## HERITAGE REPORT JUNE 2017

**CASE NO.: 16090506HB0907M**

**ADDENDUM TO HERITAGE STATEMENT: REVISED DEVELOPMENT PROPOSALS:  
ERF 5357 C/O ALEXANDER AND BIRD STREET STELLENBOSCH: PROPOSED  
DROSTDY DEVELOPMENT**

**ANALYSIS OF THE BIRD STREET STREETScape (UDScc)**

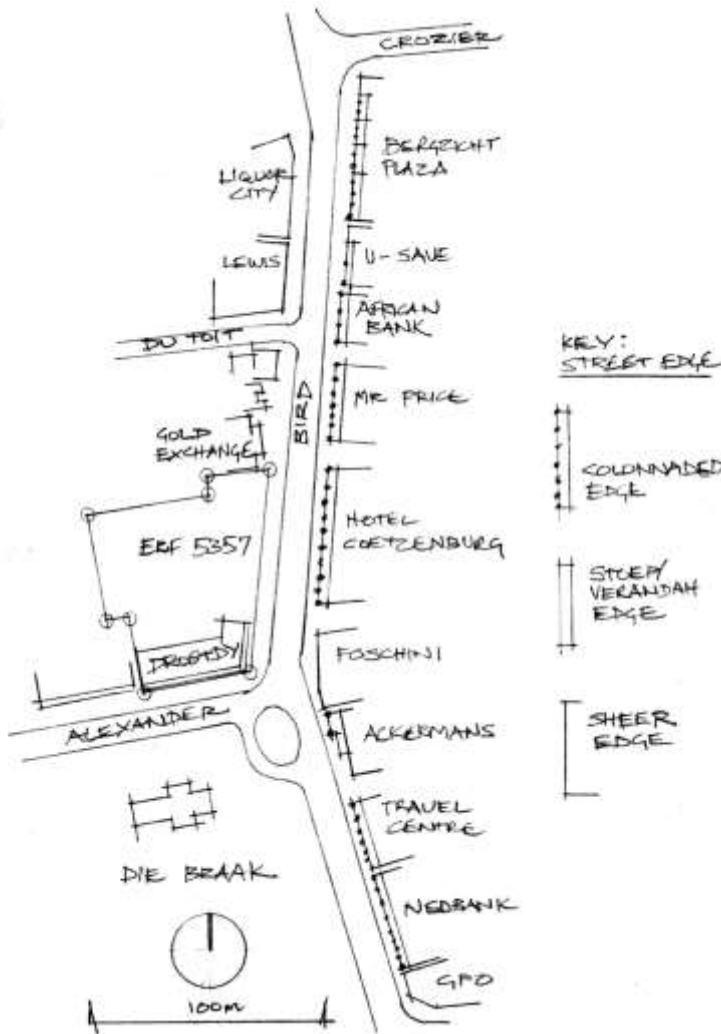
- All the frontages appear to be within the 10m height restriction as determined by the bylaw.
- There are basically 3 conditions: 1/ colonnaded (as in the case of Hotel Coetzenburg), 2/ stoep or verandah (as in the case of the existing Drostdy building) or 3/ sheer edge (as in the case of the Foschini building on the other side of the road from the Drostdy building).
- There are no colonnaded edges on the Drostdy (west) side of Bird Street; the edge condition comprises in the main sheer edges with the buildings north of the Drostdy site and south of Du Toit Street providing little support to the street.
- Other than providing support to the street frontage, transparent active edges and limiting height, there is no specific pattern to follow on the west side of Bird Street. The existing Drostdy building mainly addresses Alexander Street.
